Project Details:
Dalgise
Monkstown

Drawing Title:
Proposed Elevations + Sections - Block C

Status	Purpose of Issue	Revision
P01	PLANNING PERMISSION	
MKS-RAU-C-ZZ-DR-AR-200		P02

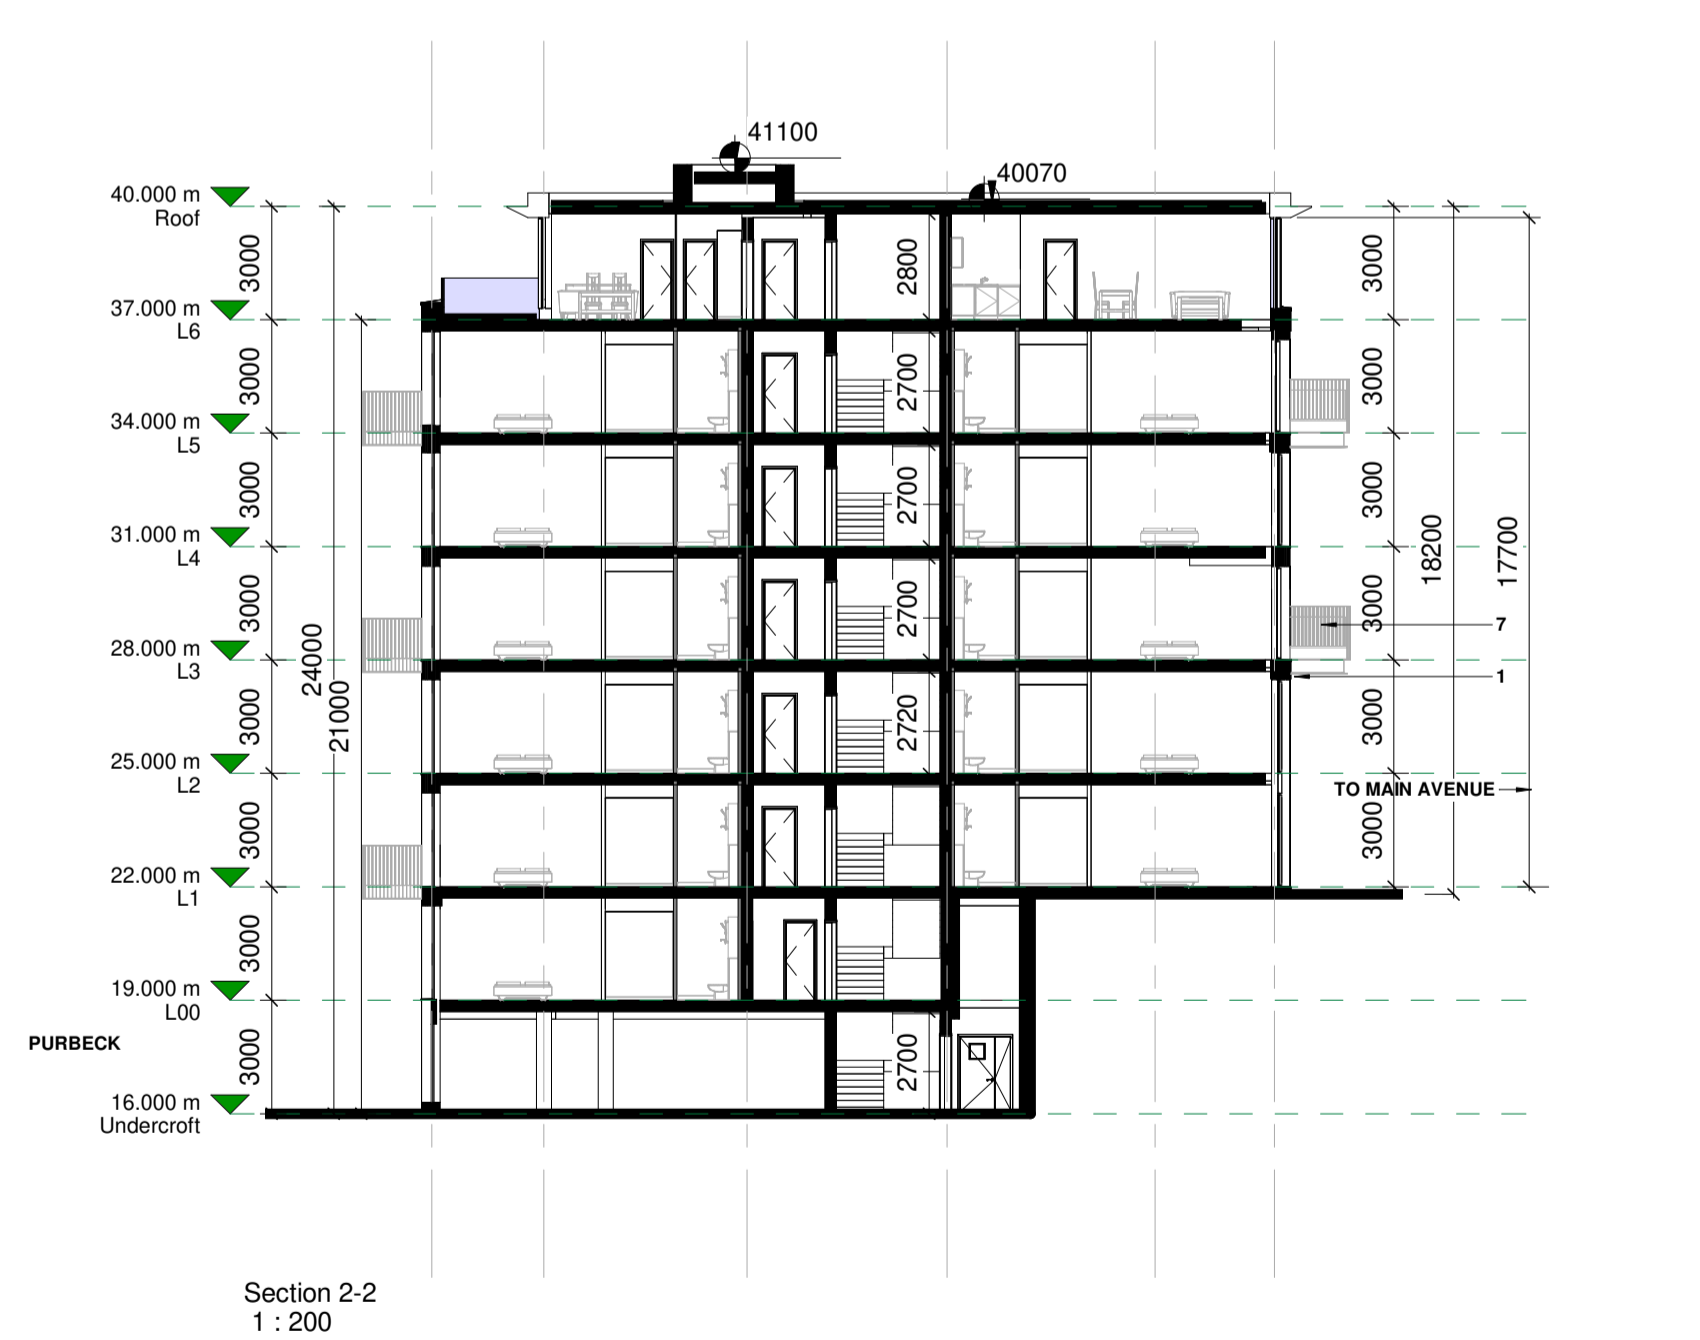
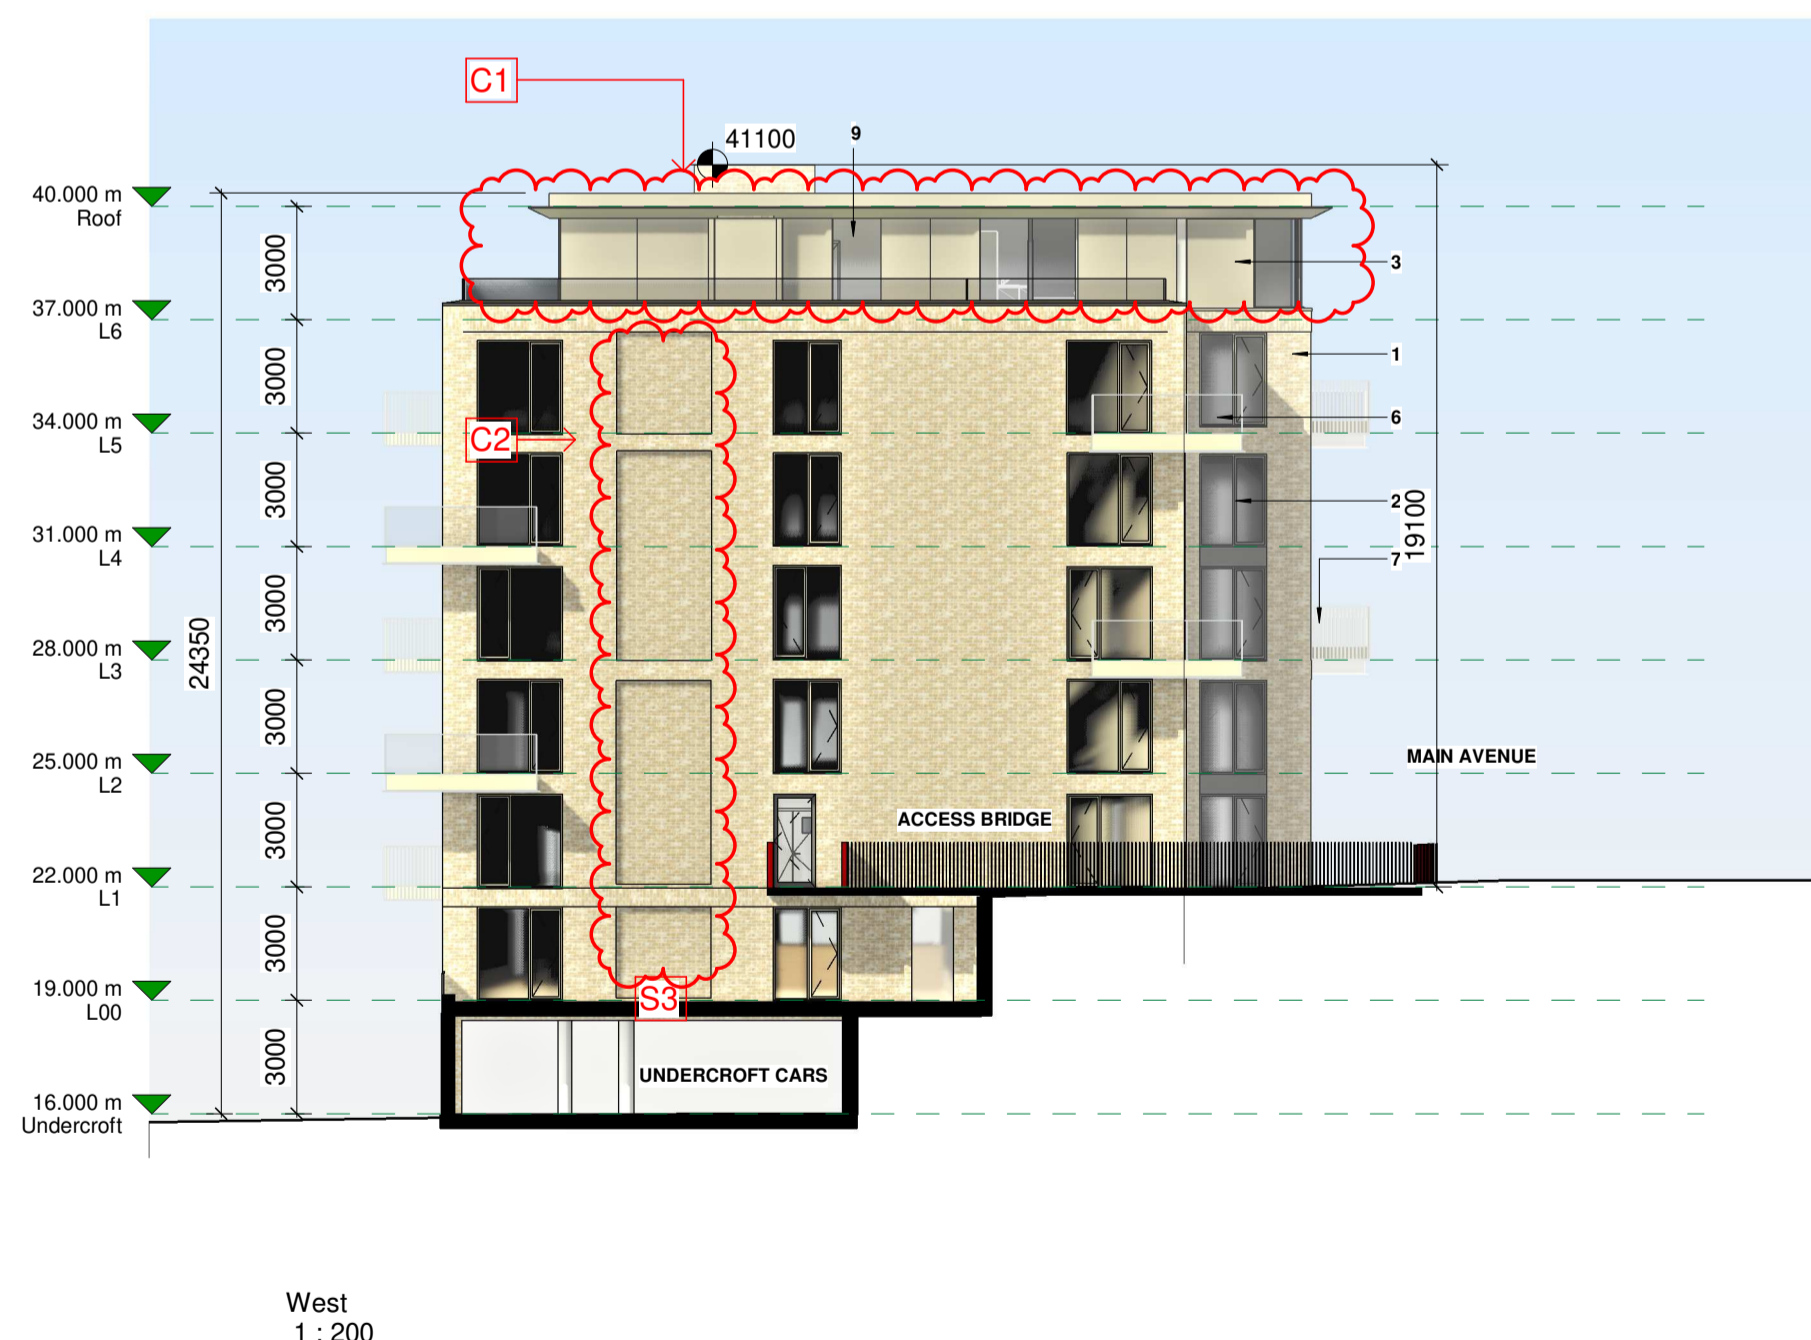
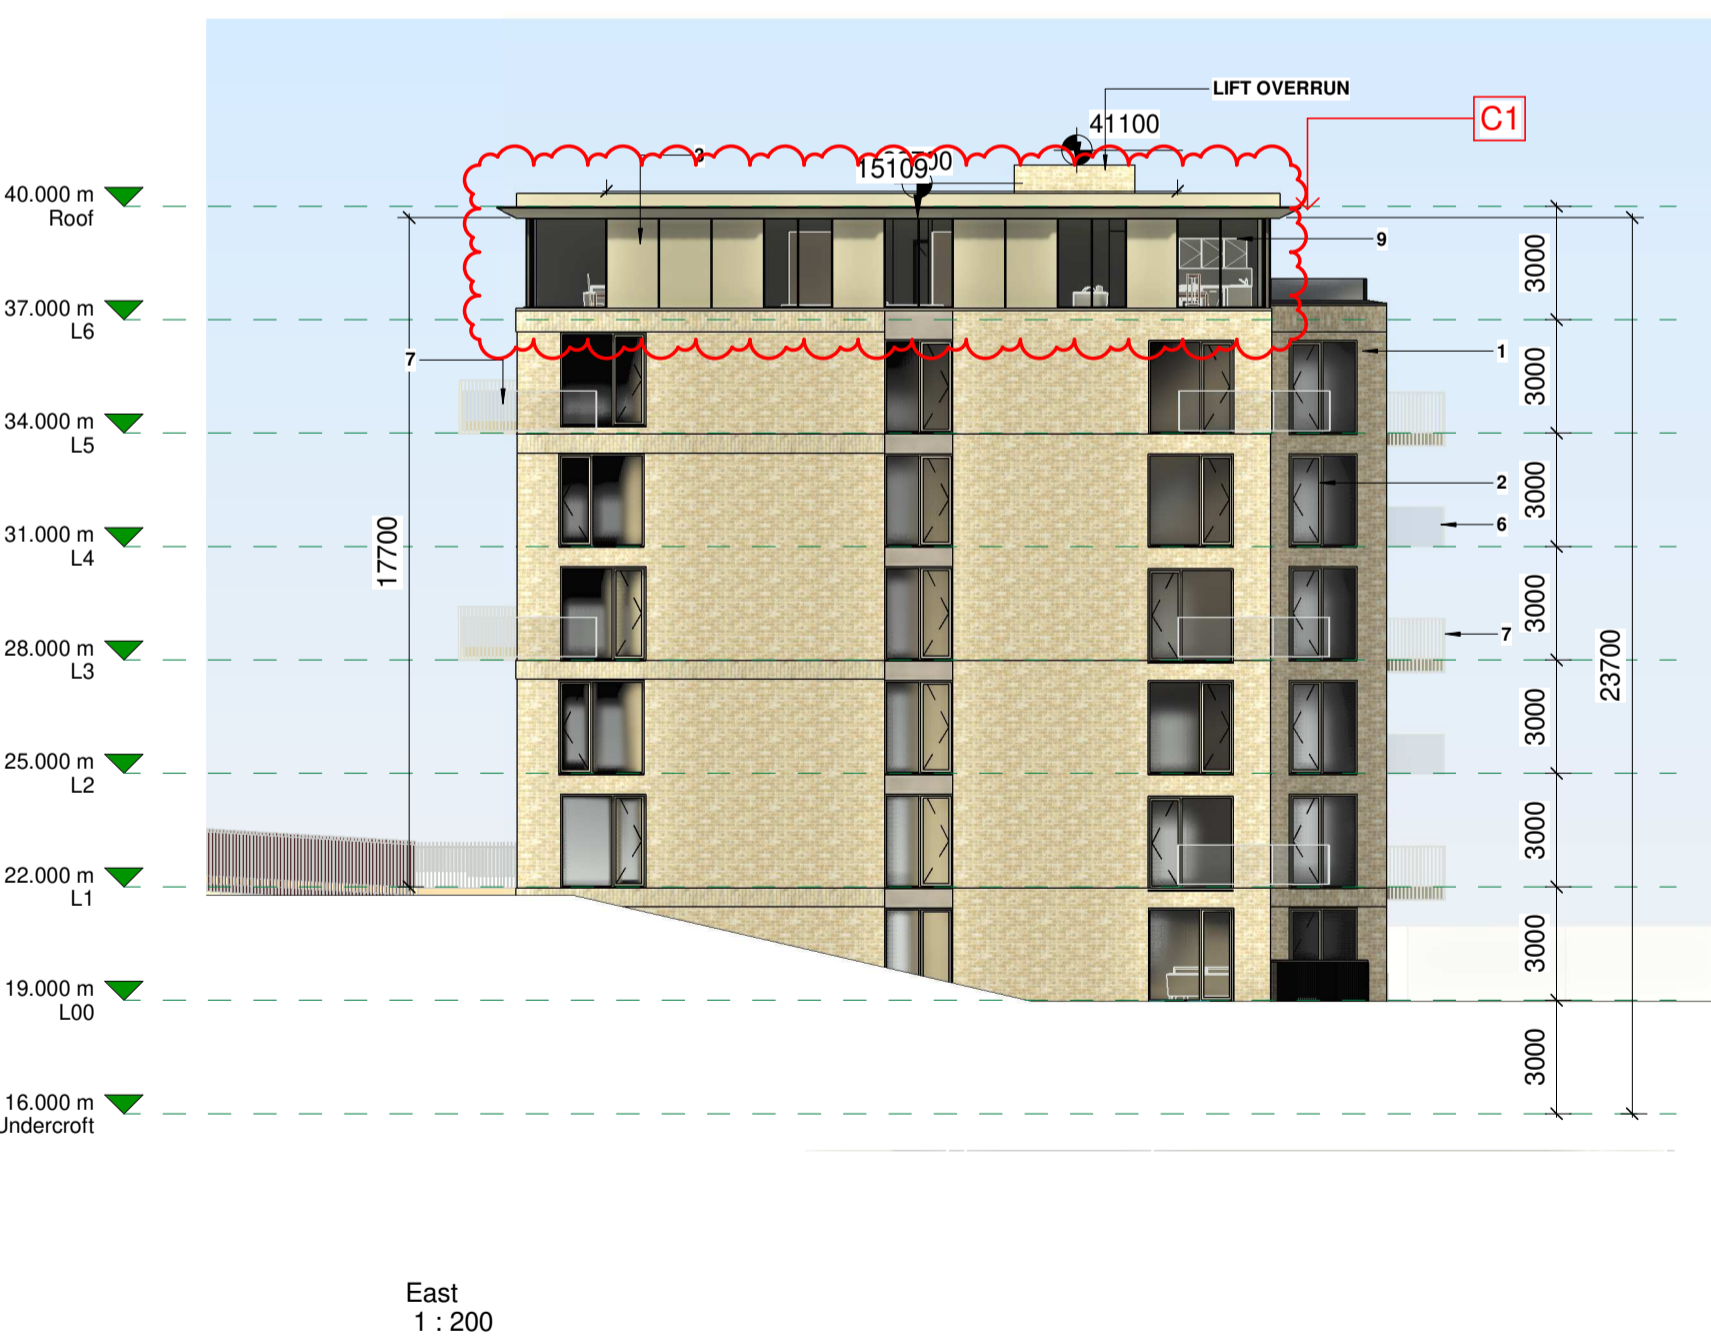
- REVISIONS**
- C1. Tonal change at penthouse level.
 - C2. Brick indent detail added to facade
 - S3. New external amenity space added ground floor between Block B+C.
 - B3. Access route to new amenity space added at Ground level (lwr)
 - B4. Private Balcony added to Apartments B_00_01 and C_00_01 (Refer to HOA for areas)
